NOTICE OF VIOLATION

On April 9, 2025, Energy Safety conducted an inspection of PG&E's WMP initiatives in the vicinity of the city of Redwood City, California. The inspection report is enclosed herewith. Energy Safety found the following violation(s):

INSPECTION REPORT

Electrical Corporation:	Pacific Gas and Electric Company
Report Number:	CAD_PGE_RMA_20250409_1346
Inspector:	Romeo Marroquin Ajcac
WMP Year Inspected:	2024
Quarterly Data Report (QDR) Referenced:	Quarter 4 (Q4)
Inspection Selection:	Energy Safety viewed the contents of the Q4 QDR and performed an analysis that resulted in the selection of the WMP initiatives and locations referenced in this report.
Relevant WMP Initiative(s):	8.1.2.10.5 – Non-Exempt Expulsion Fuses
Date of inspection:	April 9, 2025
City and/or County of Inspection:	Redwood City, San Mateo County
Inspection Purpose:	Assess the accuracy of PG&E’s QDR data, completeness of its work, compliance with WMP requirements, and compliance with its protocols.

Violation 1

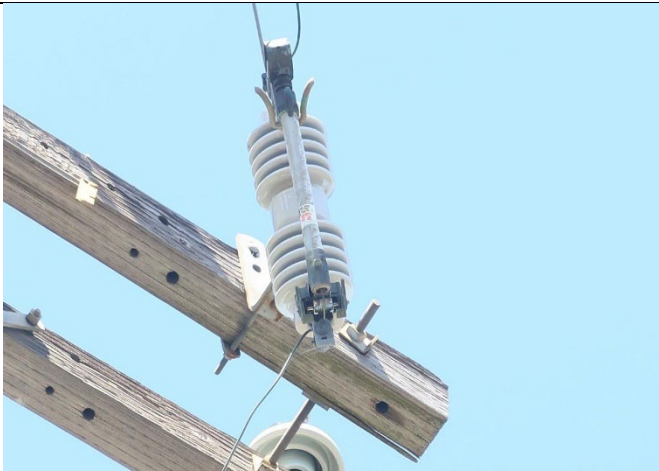
On pole ID 121589579, Grid Hardening ID 31661602 at 3827 Hamilton Way, Redwood City, CA, 94062, USA, 37.462323, -122.260922, the inspector observed a non-exempt expulsion fuse. The inspector's observation is documented in Violation 1 photographs, which are attachments to this report. Photo numbers Item1IA1Img1, Item1IA1Img3, and Item1IA1Img4 depict an incomplete installation of a non-exempt fuse. In the 2024 Q4 Quarterly Data Report submission, PG&E reported that work on WMP 8.1.2.10.5 – Non-Exempt Expulsion Fuses was completed at this location.

1. A non-exempt expulsion fuse was observed at this location.
2. PG&E reported that an exempt expulsion fuse was installed at this location.
